Type J (AD594) or
Type K (AD595) Thermocouples
Built-In Ice Point Compensation

Title		
Thermocouple Interface		
Size	Document Number	Rev
A	Thermocouple plus cold junction	B
Date:	Wednesday, March 24, 2004	Sheet 1 of 1

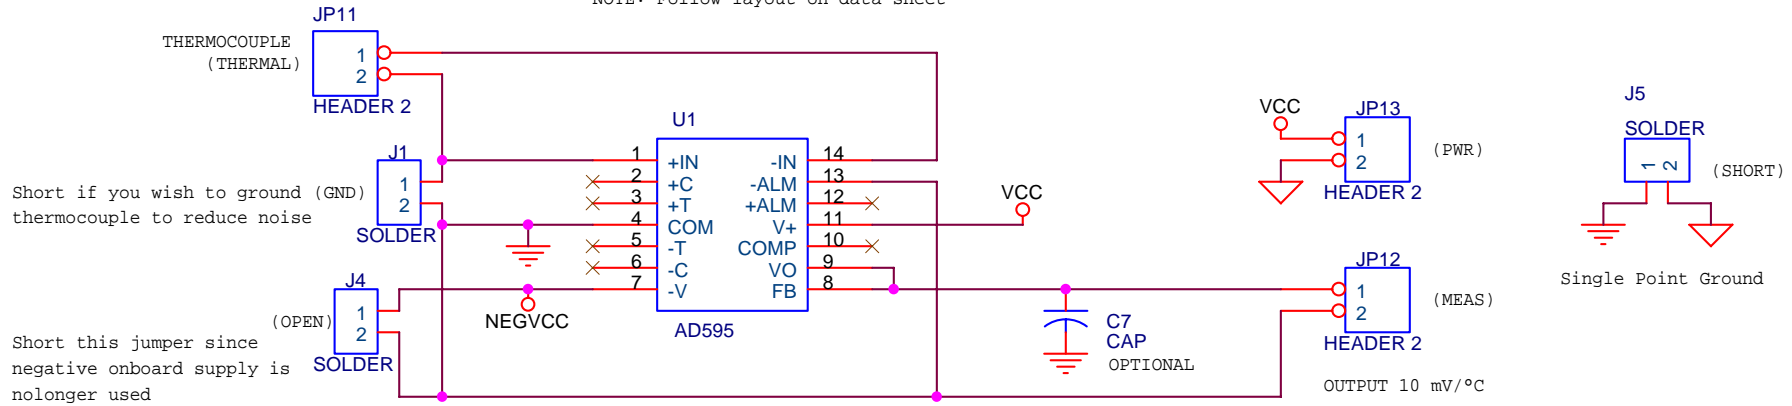
Do not implement this section.

Note: We no longer recommend using the MAX1044 due to the noise it creates. If you need to measure below 0°C you will need to provide a clean negative supply.

Short this jumper since negative onboard supply is no longer used
